# Access Compliance Report

## Public Rights-of-Way

### (Curb Ramps)

Intersection ID: 14069	Main Street: CLARICE_AV	Cross Street: E_8TH_ST	Location: E
ADA ID: 37A1BD21B174	Ramp Type: PerpDiag	Initial Pass/Fail: Fail	Overall Compliance: No
		Severity Score: 12.5

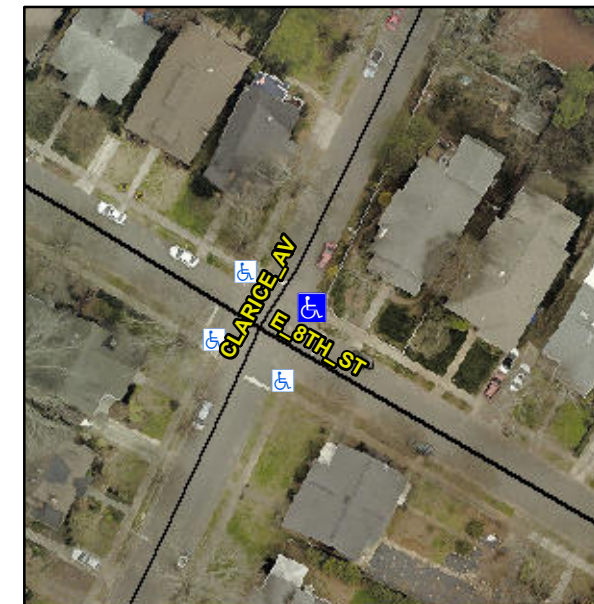
**Not Found, R304.2.2**

Compliance	Description	Data	Compliance	Description	Data
N/A	Ramp Length (in)	98.0	No	Ramp Slope (%)	9.2
Yes	Ramp Width (in)	48.0	Yes	Ramp XSlope (%)	1.8
N/A	Flare Type LT	N/A	N/A	Flare Type RT	N/A
N/A	Flare Slope LT (%)	N/A	N/A	Flare Slope RT (%)	N/A
N/A	Flare Traversable LT?	N/A	N/A	Flare Traversable RT?	N/A
N/A	Landing Length (in)	N/A	N/A	DWS Provided?	N/A
N/A	Landing Width (in)	N/A	N/A	DWS Contrast?	N/A
N/A	Landing Slope (%)	N/A	N/A	DWS Length (in)	N/A
N/A	Landing X Slope (%)	N/A	N/A	DWS Full Width?	N/A
N/A	Landing Curb? (Y/N)	N/A	N/A	DWS Offset (in)	N/A
N/A	Shared Landing?	N/A			
N/A	Gutter Ponding?	N/A	N/A	Gutter Slope (%)	N/A
N/A	Gutter Lip Ht (in)	N/A	N/A	Gutter X Slope (%)	N/A
N/A	Painted X Walk1?	No	N/A	Painted X Walk2?	No
	X Walk 1 Direction	To NW		X Walk 2 Direction	To SW
N/A	X Walk 1 Width (in)	N/A	N/A	X Walk 2 Width (in)	N/A
	X Walk 1 Slope (%)	1.4		X Walk 2 Slope (%)	2.8
	X Walk 1 X Slope (%)	2.2		X Walk 2 X Slope (%)	1.1

**Remove & Replace Curb Ramp With Two New Directional Ramps or Equivalent.**
